Location of Construction: 1061 Washington Ave		Owner: David & Donna Berry		Phone: 797-8727		Permit No: 960608
Owner Address: 1061 Washington Ave - Ptld		Leasee/Buyer's Name: ME 04103		Phone:		
Contractor Name: owner		Address:		Phone:		Permit Issued: JUN 28 1996 CITY OF PORTLAND Zone: R-3 CBL: 172-F-718 Zoning Approval: OK - 5/26/96 Special Zone or Reviews: <input type="checkbox"/> Shoreland <input type="checkbox"/> Wetland <input type="checkbox"/> Flood Zone <input type="checkbox"/> Subdivision <input type="checkbox"/> Site Plan maj <input type="checkbox"/> minor <input type="checkbox"/> mm <input type="checkbox"/>
Past Use: 1-fam dwlg		Proposed Use: 1-fam w enl deck & a/g pool		COST OF WORK: \$ 5000 PERMIT FEE: \$ 45 FIRE DEPT. <input type="checkbox"/> Approved <input type="checkbox"/> Denied INSPECTION: Use Group R-3 Type 5B Signature: <i>[Signature]</i> Signature: <i>[Signature]</i>		
Proposed Project Description: Enlarge existing deck & install a/g pool

BUILDING PERMIT REPORT

DATE: 26 June 96 ADDRESS: 1061 Washington Ave.
 REASON FOR PERMIT: Enlarge existing deck & install a/g pool.
 BUILDING OWNER: Berry
 CONTRACTOR: owner APPROVED: *1 *11 *13
 PERMIT APPLICANT: 11 DENIED: _

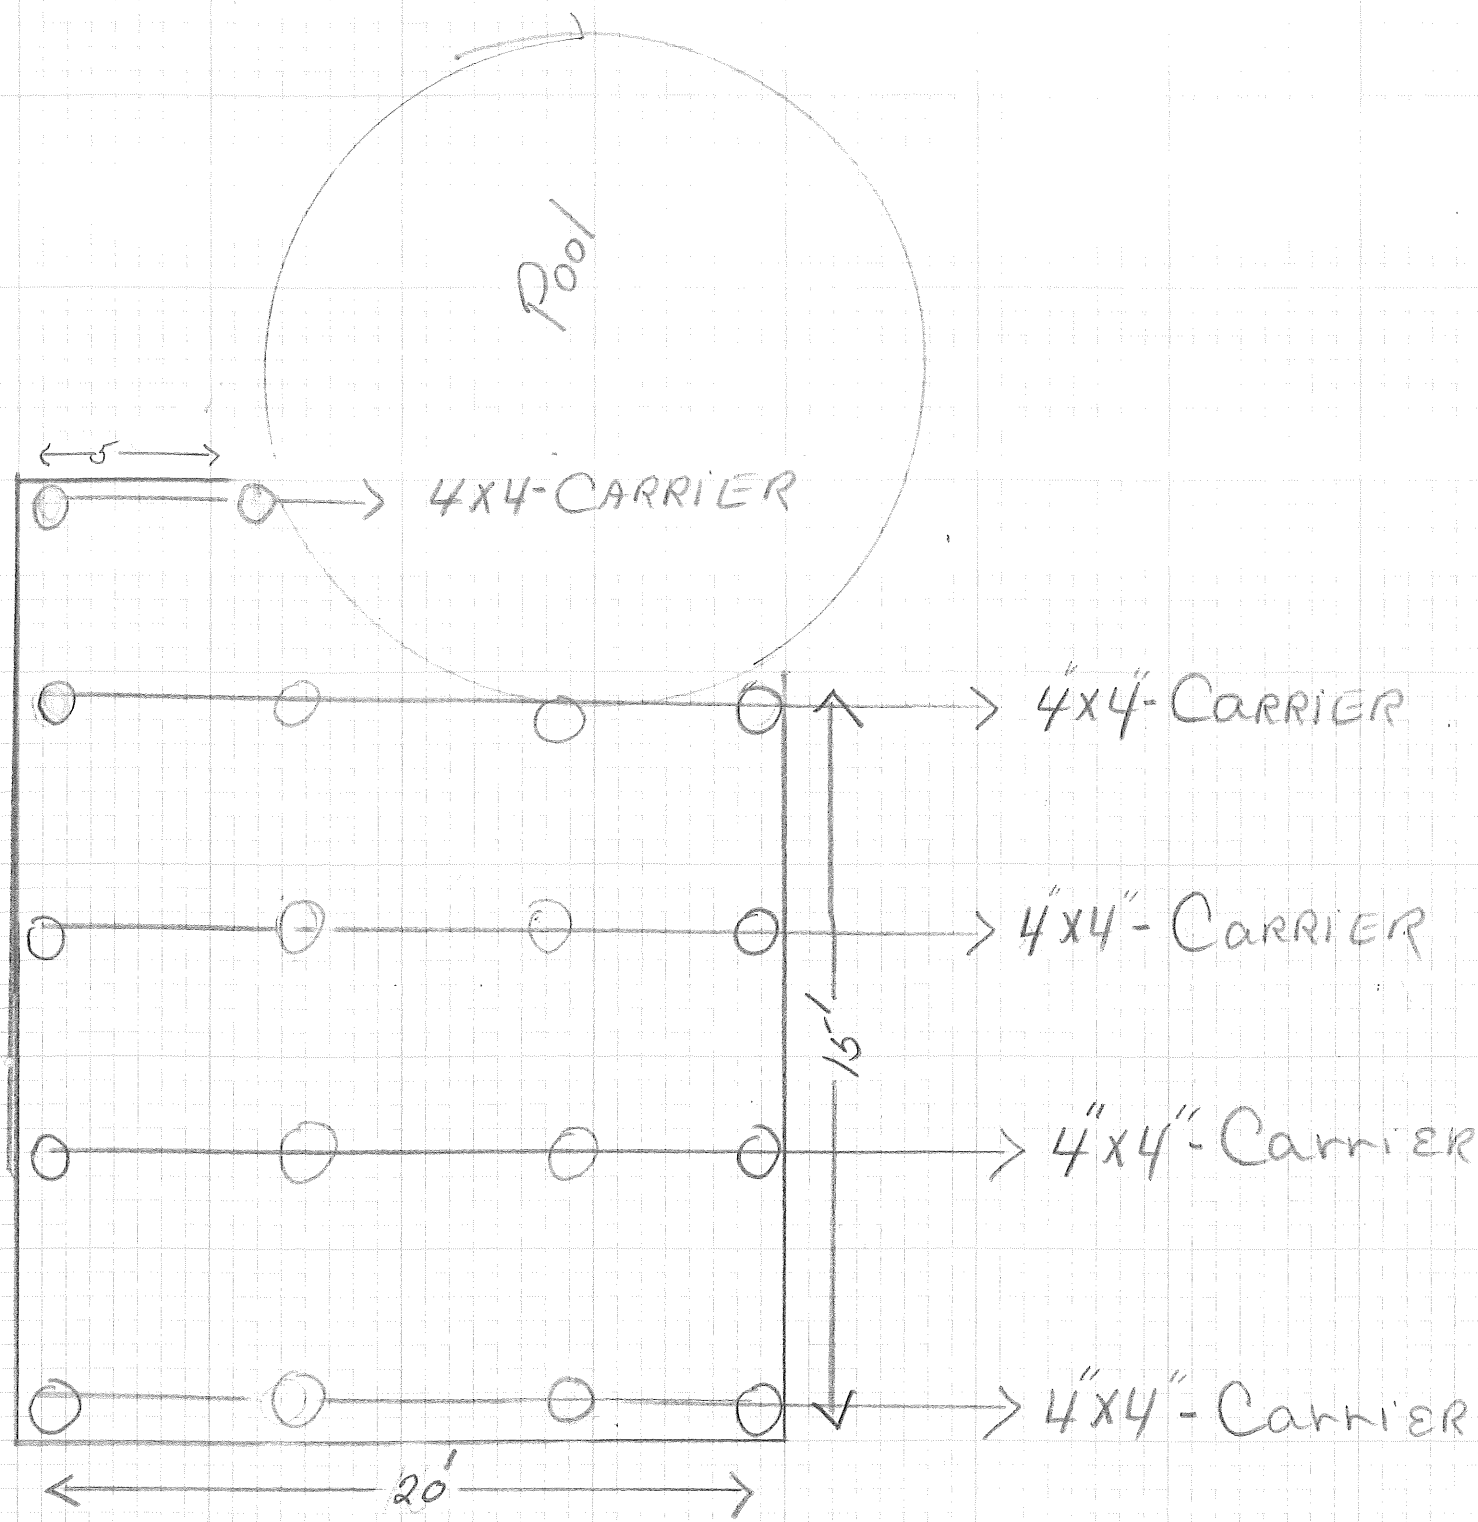
Rear Yards - 25' req - 39' shown

Side Yards - 8' req - 8' shown

→ HAS 10' Around

2x6-STRINGERS EVERY 16"
 O=6" SONER Tube EVERY 6' Feet

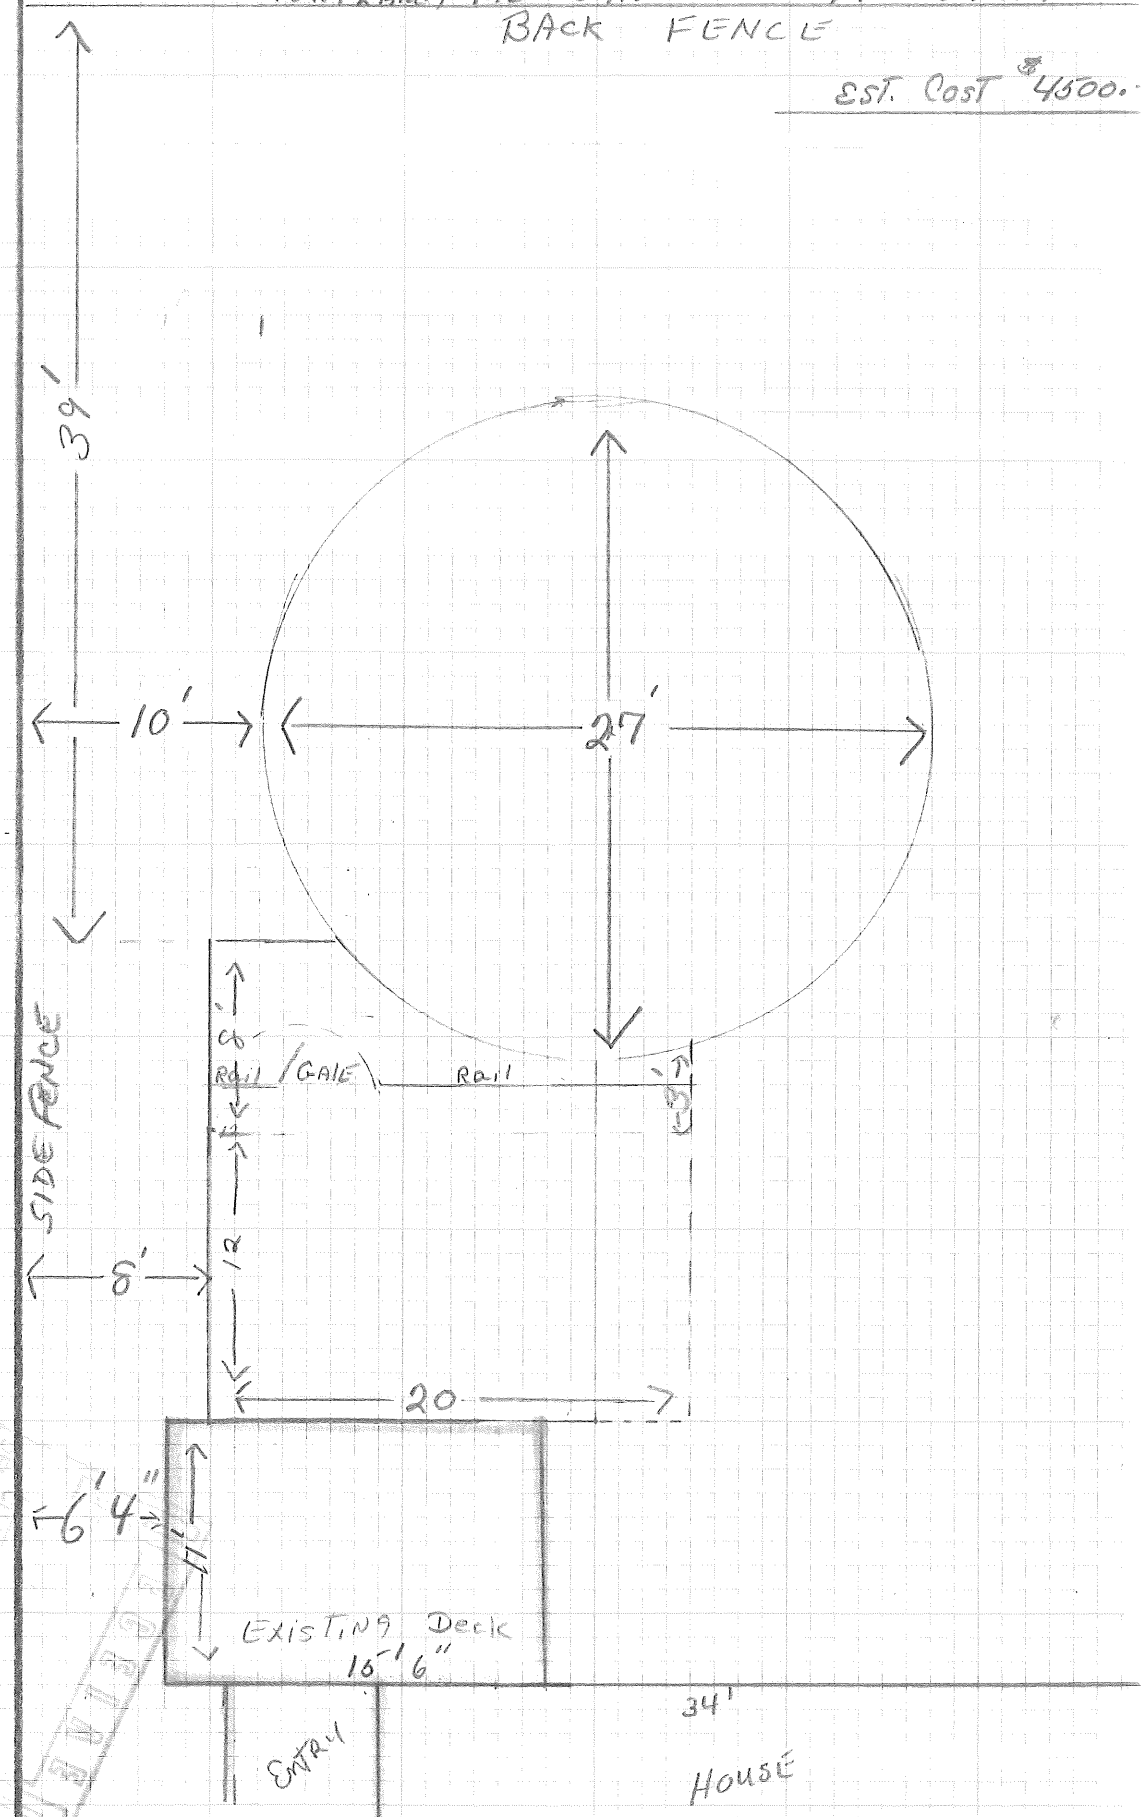
- X 11. Guardrail & Handrails-A guardrail system is a system of building components located near the open sides of elevated walking surfaces for the purpose of minimizing the possibility of an accidental fall from the walking surface to the lower level. Minimum height all Use Groups 42", except Use Group R which is 36". In occupancies in Use Group A, B, H-4, I-1, I-2 M and R and public garages and open parking structures, open guards shall have balusters or be of solid material such that a sphere with a diameter of 4" cannot pass through any opening. Guards shall not have an ornamental pattern that would provide a ladder effect.

- X 13. Stair construction in Use Group R-3 & R-4 is a minimum of 9" tread and 8-1/4" maximum rise. ~~All other Use Group minimum 11" tread, 7" maximum rise.~~
